SUBJECT: Forwards FSAR changes, including deviation from Rev 1 to
 Reg Guide 1.52 & rev to 10CFR50.73 re nonroutine
 reportability requirements. Changes will be included in next
 FSAR update.

Subject: Palo Verde Nuclear Generating Station (PVNGS)
Units 2 and 3
Changes to PVNGS FSAR on Various Subjects
Docket Nos. STN-50-529/530
File: 85-056-026; G.1.01.10

Figure 3.6-4

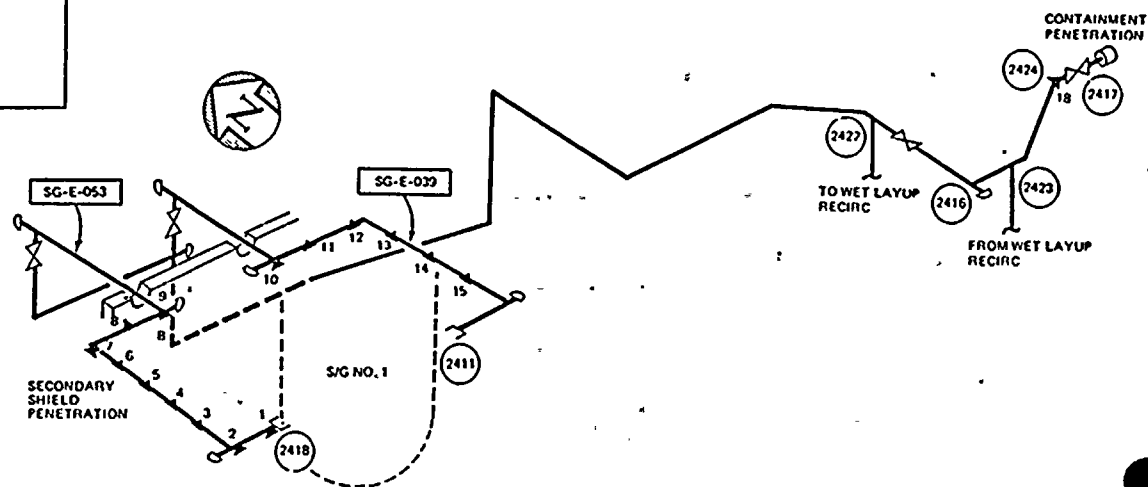
(XJ-SQN-RU-143 AND XJ-SQN-RU-144)
